## MINI THERMOSTAT REDESIGN TO OVERCOME OVERHEATING ISSUES

Issue Date: 23/09/19 Issue Number: COTB0027F

**APPLICATION:** MINI R55, R56, R57, R58, R59, R60, R61

APPLICABLE REFERENCES: FTK396 / FTK487

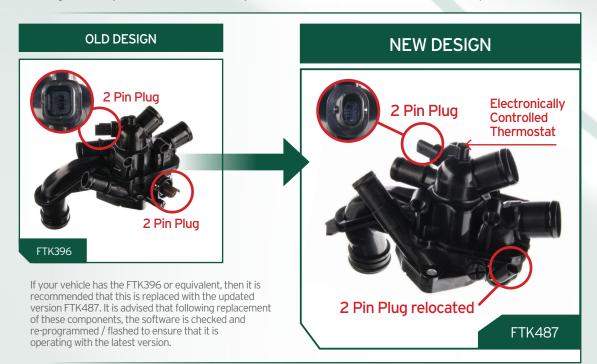
Due to an increase in overheating issues & symptoms such as an erratic temperature gauge, erratic running, radiator fan run-on, or poor heater function in the above vehicles, the O.E.M. have modified the design of the Thermostat housing. Following the O.E. specification, we have replaced the old design FTK396 with the new latest design FTK487. The latest design benefits from an electronically controlled thermostat, a reinforced structure, and a new configuration of sensors.

We have highlighted the key differences below so that you are clear that the latest part, although visually different to what may be on the vehicle, is in fact the correct product.

The modified version has had the lower 2 Pin connector relocated, therefore, a new cable may also be required to carry out the modification.

New Cable: FTS3092- Thermostat Wiring Harness
